Hill Farm Lot 12 Block A, Administrative Subdivision Plan No. 620200100

Hill Farm Lot 12 Block A, Administrative Subdivision Plan No. 620200100: Application to create one lot without frontage; +/-2.01 acres, on Norwood Road, located approximately 1,500 feet west of the intersection of New Hampshire Avenue and Norwood Road, Parcel: P715, Residential Estate (RE-2) Zone, 1997 Cloverly Master Plan.

Recommendation – Approval with conditions

Figure 4 - Tree Variance

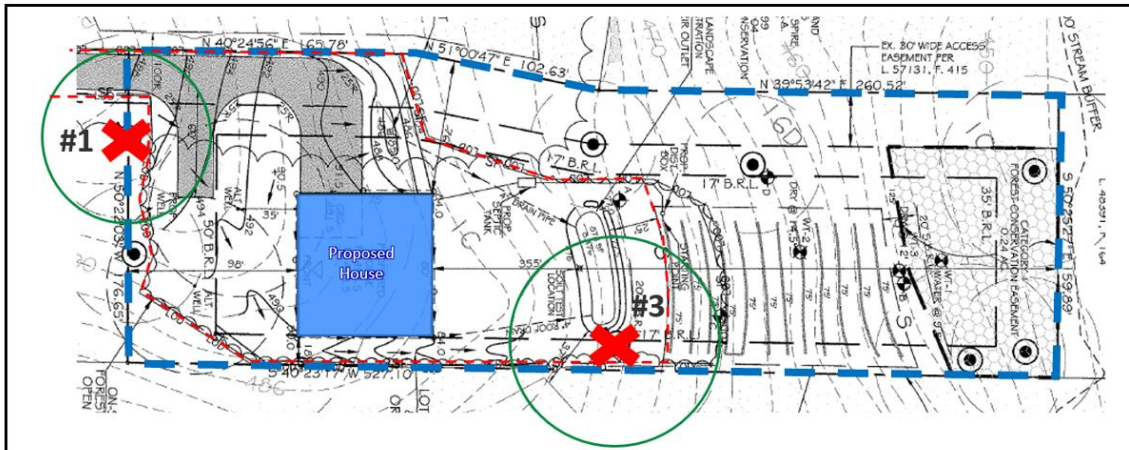
The Applicant submitted a variance request in a letter dated August 12, 2020 (Attachment D) to remove two (2) Protected Trees that are 30 inches or greater, DBH, and are considered a high priority for retention under Section 22A-12(b)(3) of the County Forest Conservation Law. Details of the Protected Trees to be removed are described in detail in the Applicant's letter and shown graphically on the Forest Conservation Plan. A summary of the tree variance request is provided in Table 4 and Figure 4 below.

Tree #1 is located adjacent to an existing access easement for the Property, where the extension of an existing driveway is anticipated to be constructed to provide access to the Subject Property. The construction of the driveway, including the turnaround for fire department vehicles, is necessary to provide access to the Property and requires impacts to the critical root zone of this tree to the extent that the tree cannot be retained. If the impacts to the critical root zone of Tree #1 were not permitted, the proposed driveway to access the Property could not be provided. Tree #3 is located in the middle of the Property and will be impacted by the proposed stormwater management facility. These impacts will require this Protected Tree to be removed. The Property is narrow in configuration and constrained on one side by the existing access easement where the driveway will be located. The required setbacks and the location of the required septic field dictate the location of the proposed house. Stormwater management features are required to treat the runoff from the house and driveway. These existing conditions are such that any application to develop this Property for the recommended use would result in the need for a tree variance. The number and location of the Protected Trees within the developable portions of the Property, and the development requirements create an unwarranted hardship. If the variance were not considered, the development anticipated on this Property would not occur. Staff has reviewed this Application and finds that there would be an unwarranted hardship if a variance were not considered.

Staff recommends that the variance be granted.

Figure 3 – Administrative Subdivision Plan

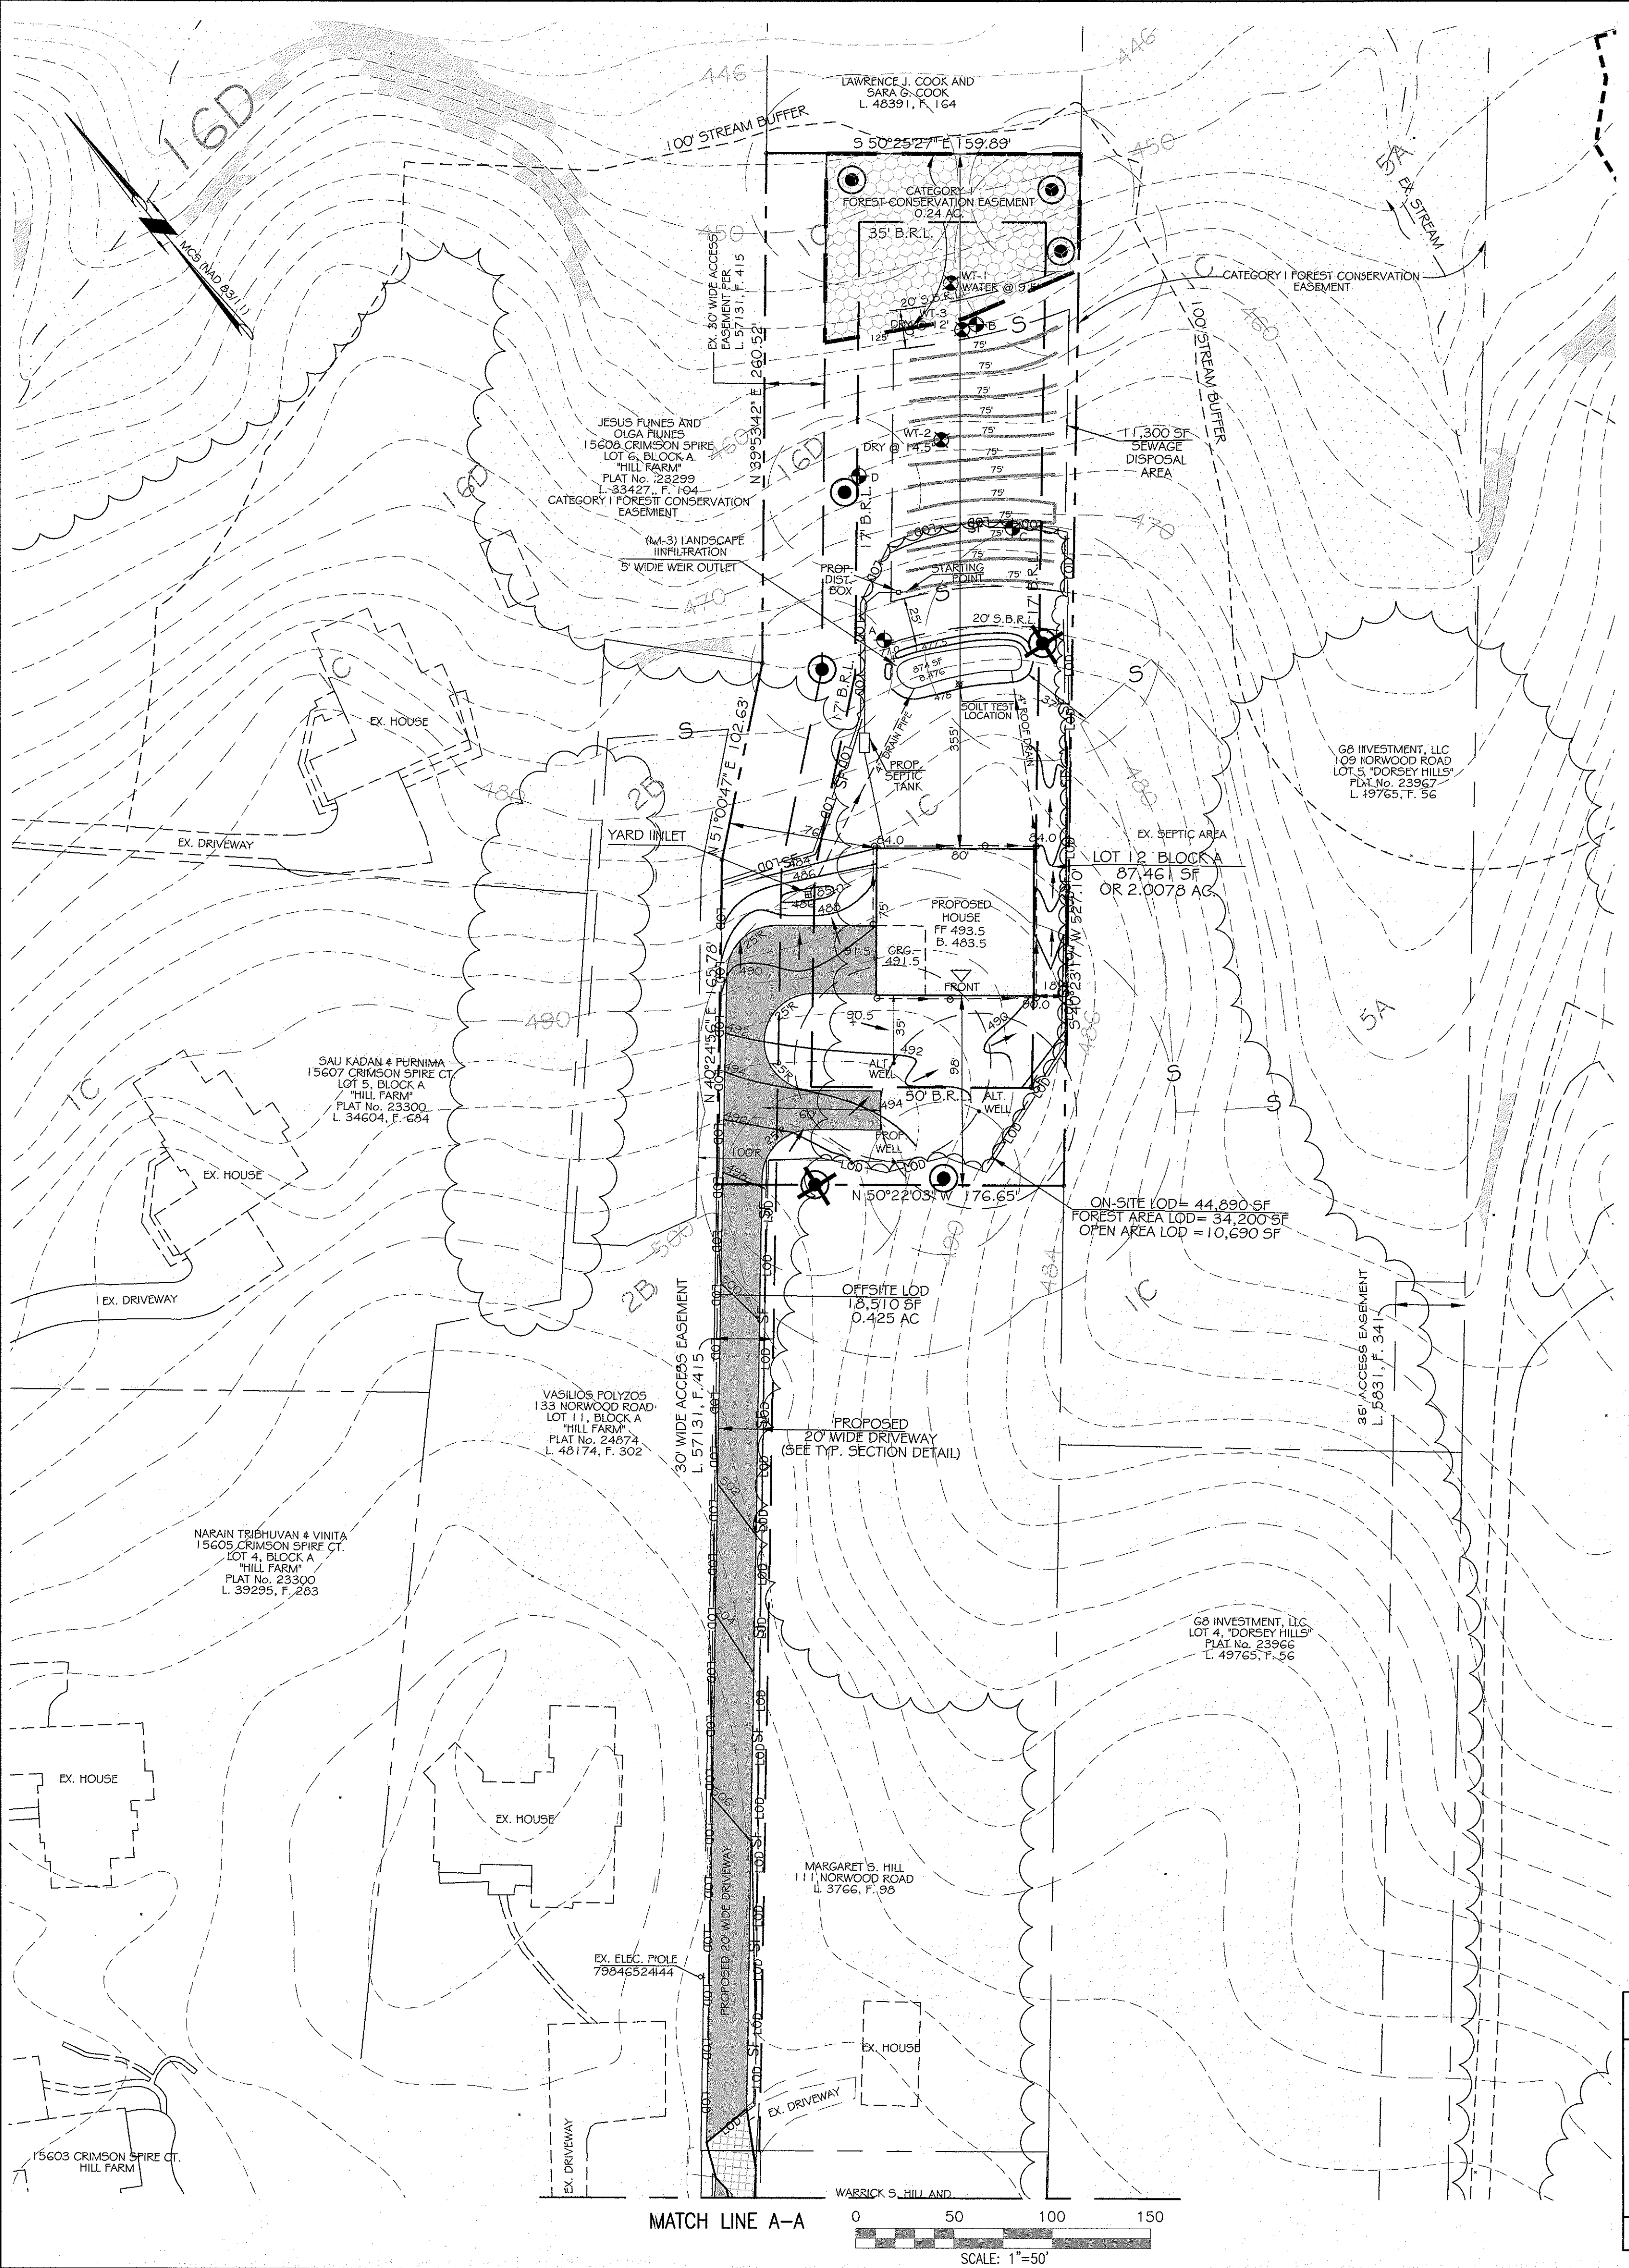
The Administrative Subdivision Plan No. 620200100 (“Application”) is a request to create one +/-2.01-acre lot to accommodate a single-family detached house as shown in Figure 3. The Property will be accessible from Norwood Road through an existing 12-foot wide driveway. As part of the Application, the existing driveway will be widened by an additional 8-feet for a total of 20-feet. The driveway will also be extended from where it currently terminates (abutting southern parcel) to the Subject Property. As proposed, the Property will not front along a public or private street. The Planning Board findings for a lot without frontage are detailed in the Analysis and Findings section in this report.

The Application proposes an 0.24-acre Category I Conservation easement to protect existing, retained forest on the Property. A new well and septic system will also be installed to serve the Property. As proposed, stormwater management goals will be met via landscape infiltration. This Application also includes a combined Preliminary/Final Forest Conservation Plan (FCP) No. 620200100 and a tree variance request to remove two specimen trees (Attachment C & D).
